CITY OF ST. HELENS PLANNING DEPARTMENT

MEMORANDUM

TO: Planning Commission acting as the Historic Landmarks Commission
FROM: Jennifer Dimsho, AICP, Associate Planner
RE: 71 Cowlitz Street (The Klondike Tavern) Architectural Review
DATE: April 4, 2023

AS-IS FIRST FLOOR LAYOUT

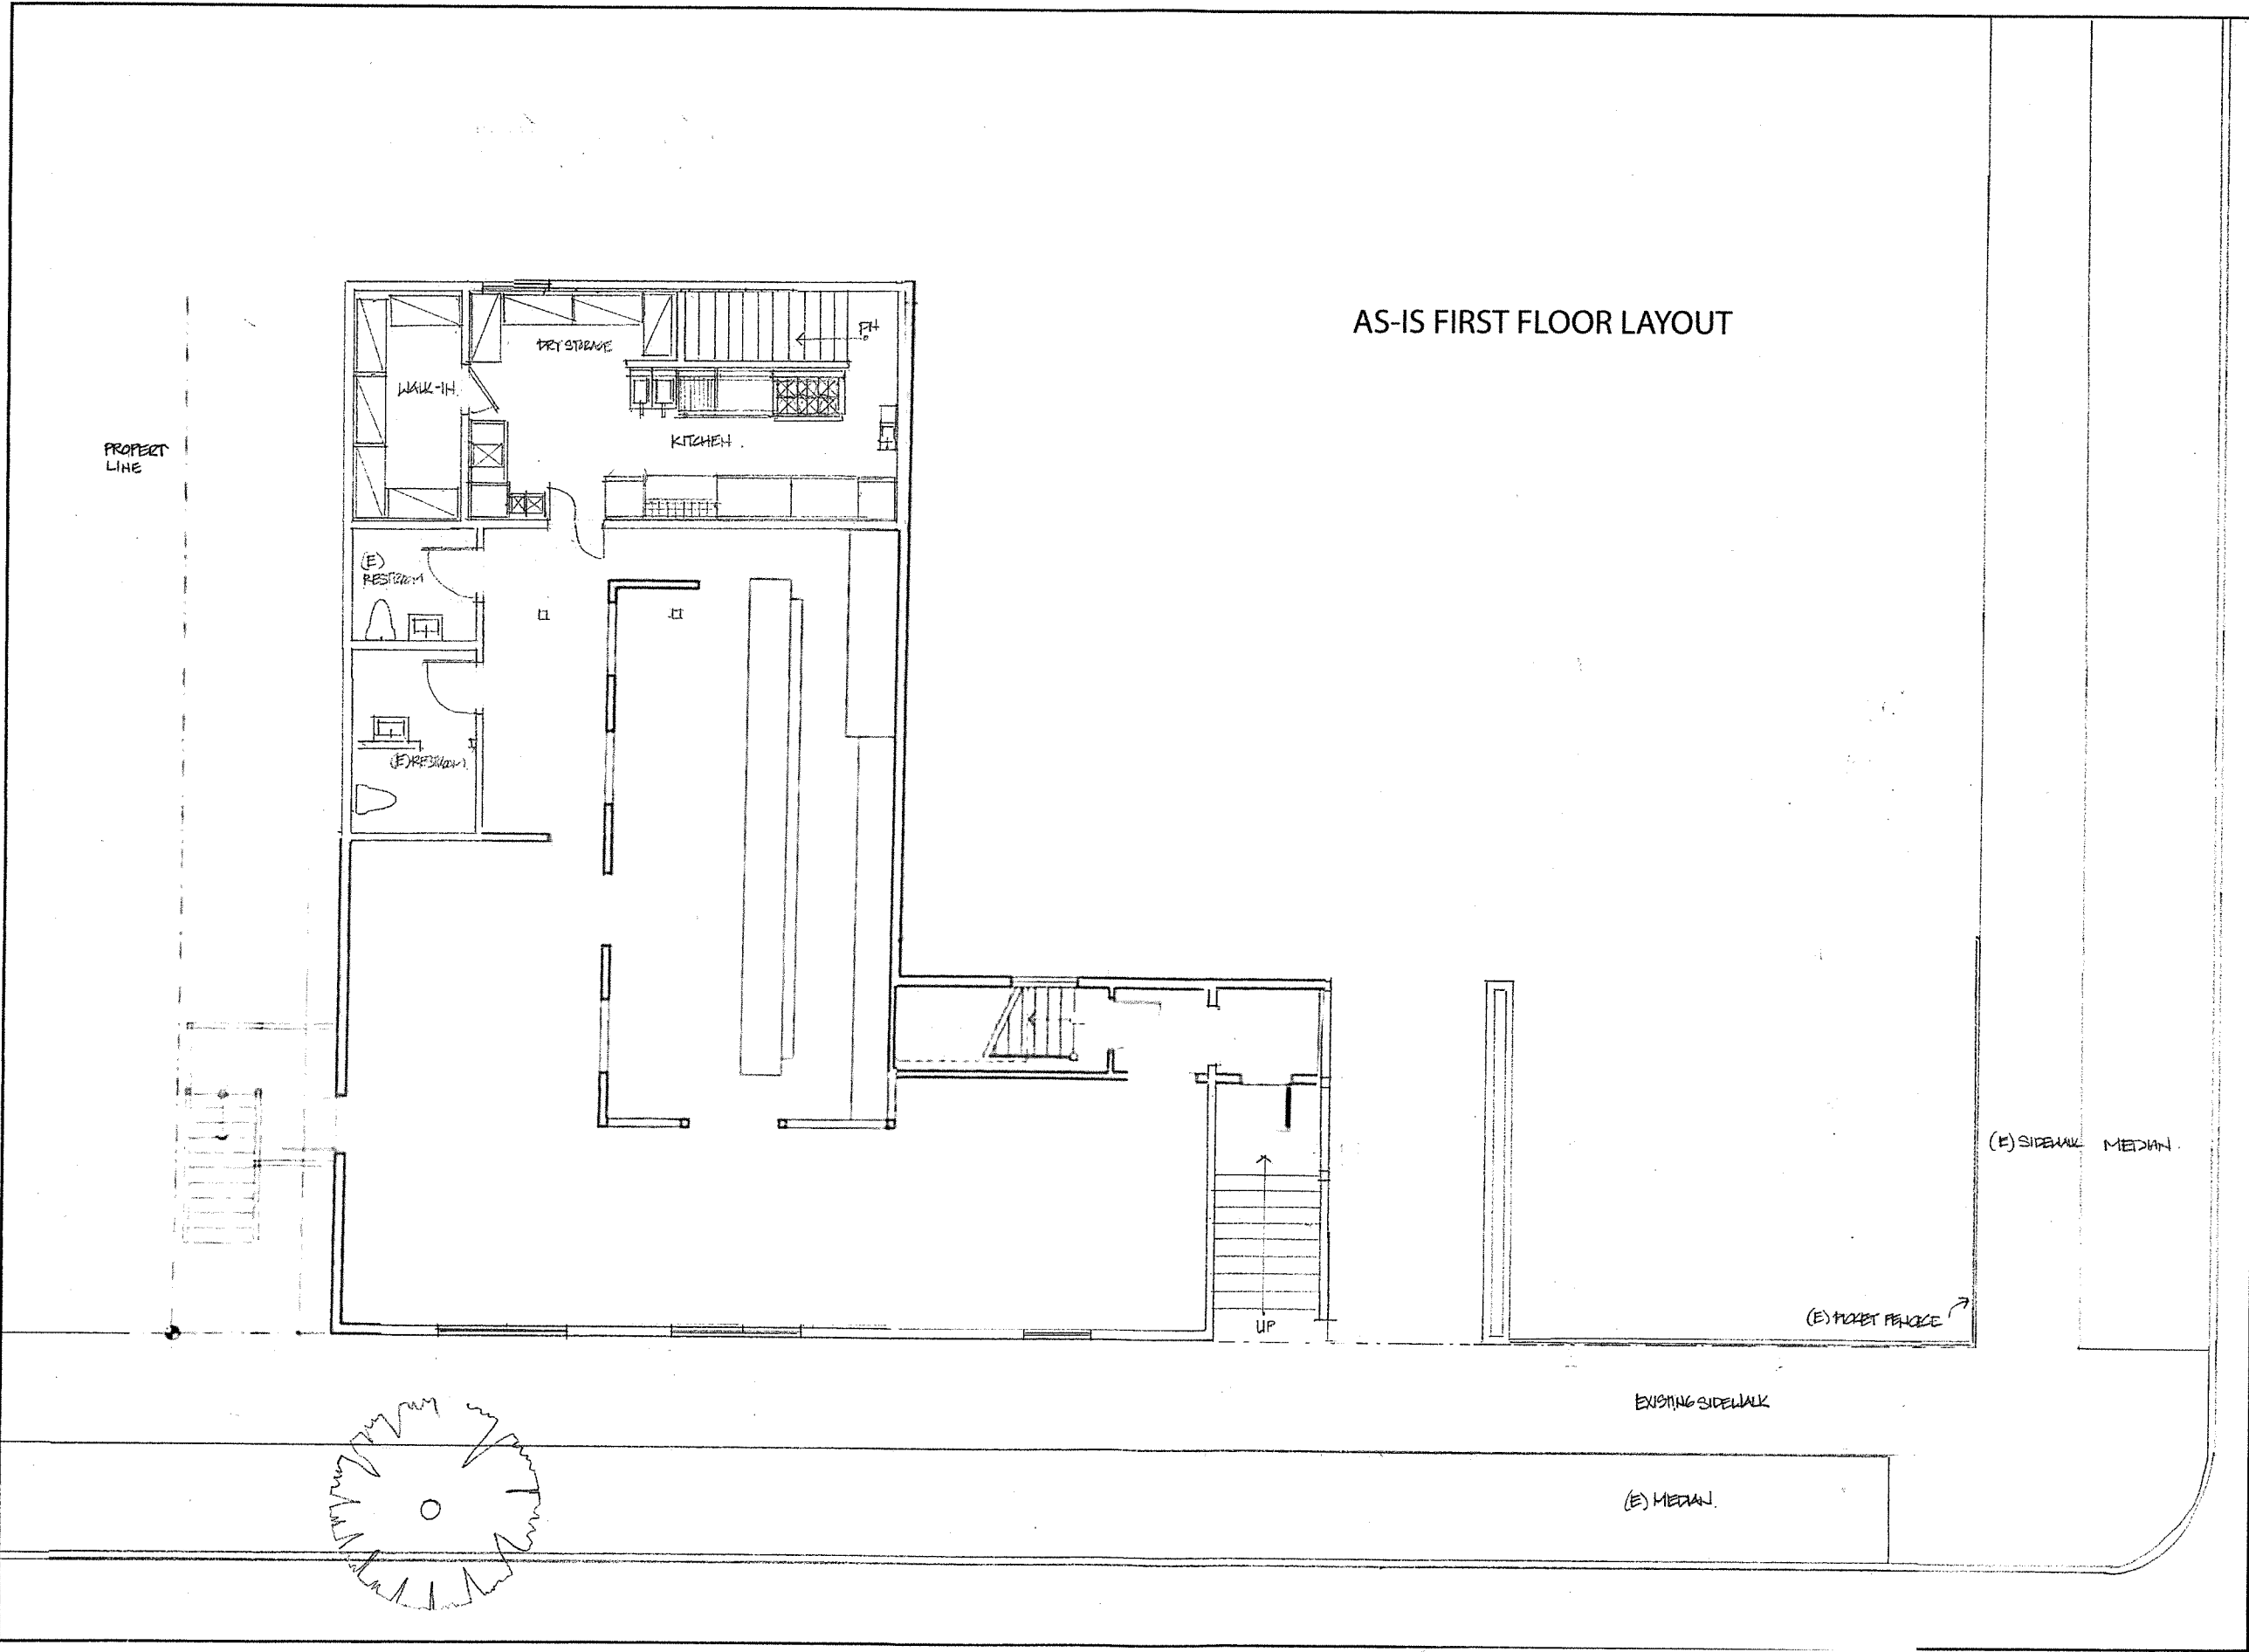
The Guidelines discourage the use of bright, unfinished metals. The ADA lift will be made of metal. Its location is tucked between the main entry and the proposed porch, so it will not be as visible as the existing entry stairway. **The applicant indicates in the narrative they will paint the exterior facing gate of the lift the same color as the siding, but it is not shown in the plans. Revised plans submitted with the building permit shall include this.**

ADA LIFT: The exterior lift visually tucks "behind" the building's entry vestibule, and we will be painting the exterior facing gates the same color as the building siding.

Existing Southern Elevation

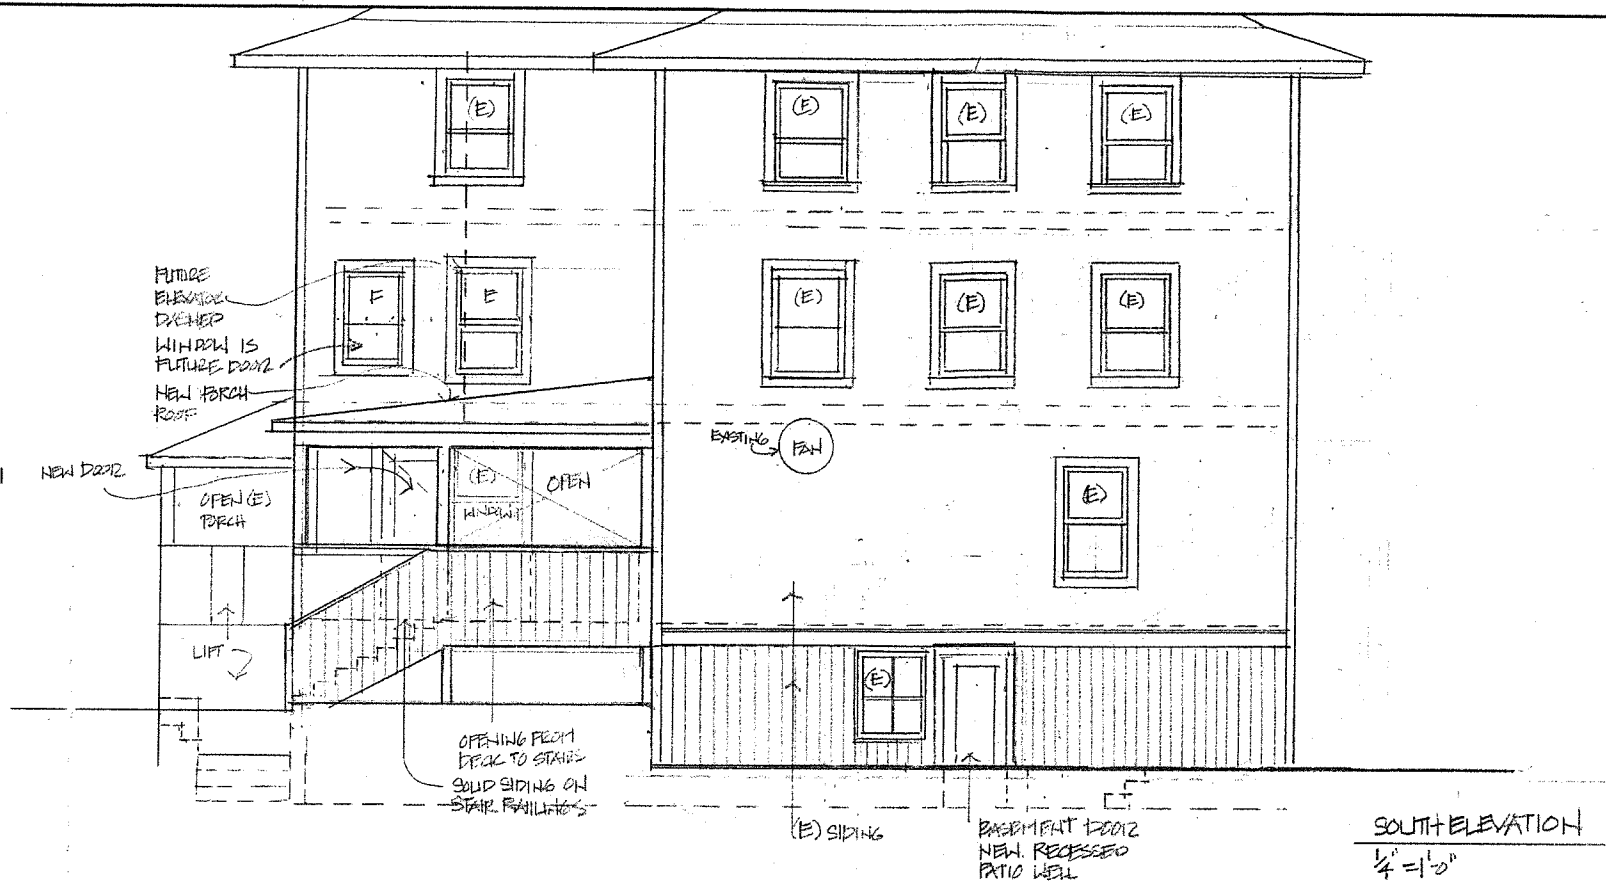
The applicant is proposing vertical wood shiplap siding for the porch addition with 1x6" trim which will be painted to match the existing colors of the building. The existing building has matching vertical skirt siding as shown below.

Porch and stair siding to match
Existing vertical skirt siding
And 1x6" trim.

Existing Western Elevation

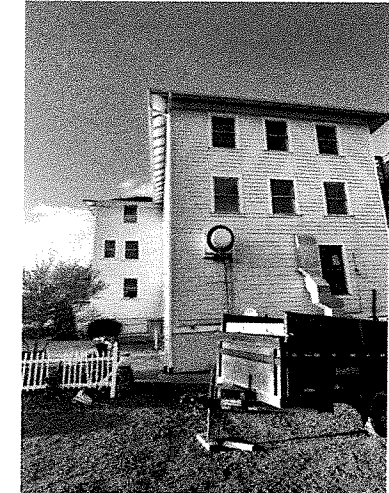
There are no new windows proposed with this project. However, the applicant is proposing to install a new door in a historically covered window opening, a photo of which was provided in the plan set.

Historic Boarded Up Window Opening
